Residential Re -development of Crushintons

Land at Crushintons Ltd, Sandfield Farm, Northwall Road, Deal, CT14 6PP

Contact: [REDACTED]
E-mail: [REDACTED]@dover.gov.uk
Our ref: PE/23/00131
Date: 22/2/2024

Proposal: Erection of up to 30 no. dwellings with associated landscaping and biodiversity enhancements

DRAWING TITLE
Opportunities & Constraints

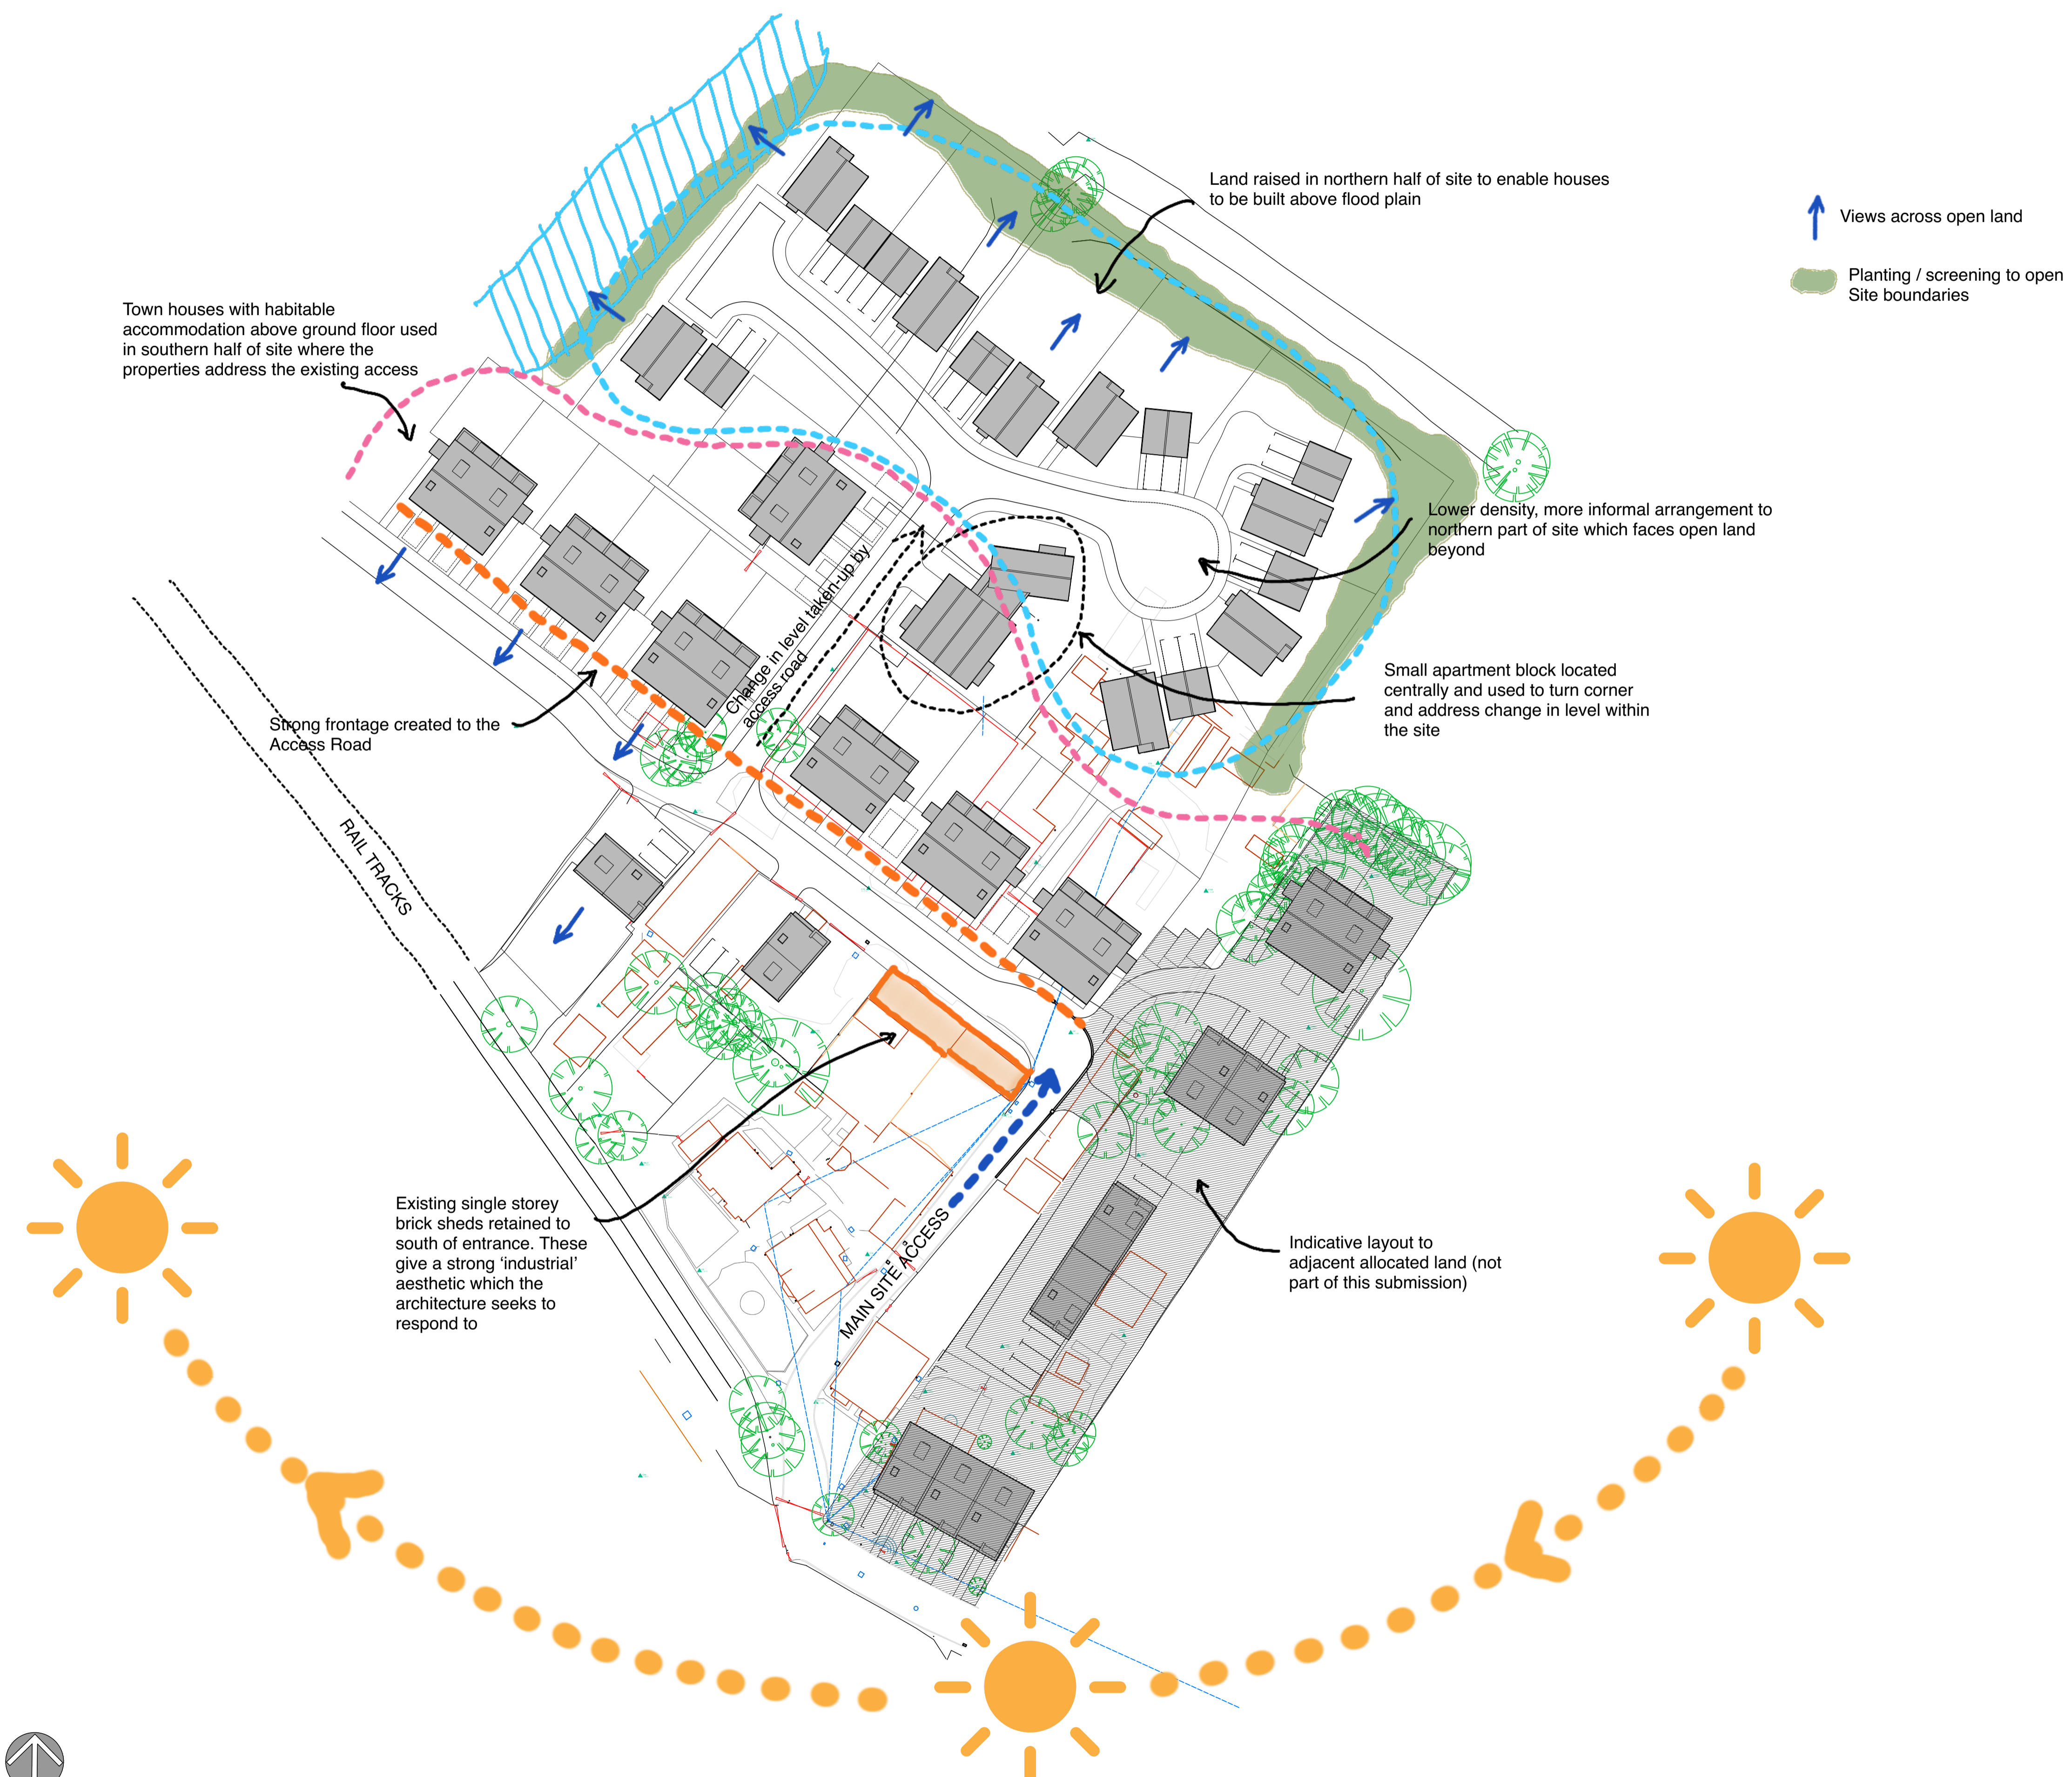
In terms of the layout of the site, we have some concerns at this stage and would suggest alternative layouts are considered, which could also provide more variety in unit sizes to accommodate the housing mix required (discussed further below). In respect of the design of the 3 bed house, by having the entrance porch set back from the main front elevation, whilst being handy for access from the adjacent parking space, provides a rather blank elevation at ground floor level, with overlooking of the street from first floor level only. To create a more active street scene, you may wish to consider moving the door to be adjacent to the garage; a similar approach taken to development at Willowbank in Sandwich which required there to be no habitable accommodation at ground floor level due to flood constraints (albeit used a more traditional design and materials given the context of the historic settlement). Elsewhere, (e.g. Lydden and near Fort Burgoyne) creating integral car ports to some of the units has helped to create more interaction at ground floor level.

The range of materials and variety in building orientation would work well, creating visual interest which could be further enhanced with landscaping (and a landscaping scheme could be submitted as part of an application). In terms of the building heights, the surrounding area contains bungalows, chalet bungalows and two storey dwellings generally finished in brick; some with sections of tile hanging, cladding, and some in render. The indicative elevations and floor plans suggest the proposals would be 2 and 2 ½ storey dwellings. At this stage, it is not clear to what extent the land level would need to be raised due to flood risk and I

(with the indicative plans showing the scheme of 28no. units). Based on the 'site plan as proposed', it is not clear if sufficient parking would be provided for each of the dwellings, with plots 21-26 having only 1 parking space despite being 3 bedroom dwellings (I note the indicative elevations show internal ground floor parking, however the site plan indicates landscaping to the front of these dwellings which could affect access). I would recommend you seek clarification of the parking provision requirements based on the number of bedrooms per unit from KCC Highways and Transportation, as well as guidance on the required level of visitor parking, to ensure this can be designed into the scheme (and as there is limited on-street parking available in the surrounding area).

would recommend sections through the site are provided with any forthcoming application, giving some context to the ridge and eaves heights of neighbouring dwellings and land.

It would also be of assistance to show street scene elevations and I would recommend that street tree planting is considered (which would also accord with the objectives of draft policy CC8 and could assist in the integrated design of surface water drainage and biodiversity enhancements). To add some further variety, you may wish to consider adding picture window surrounds to some of the front elevations of the 4 bed units, or using sections of brick patterns or protruding brickwork to create further visual interest. I would recommend that details of street lighting are included in any forthcoming application, and it is clarified if the intention is for this to be adopted.
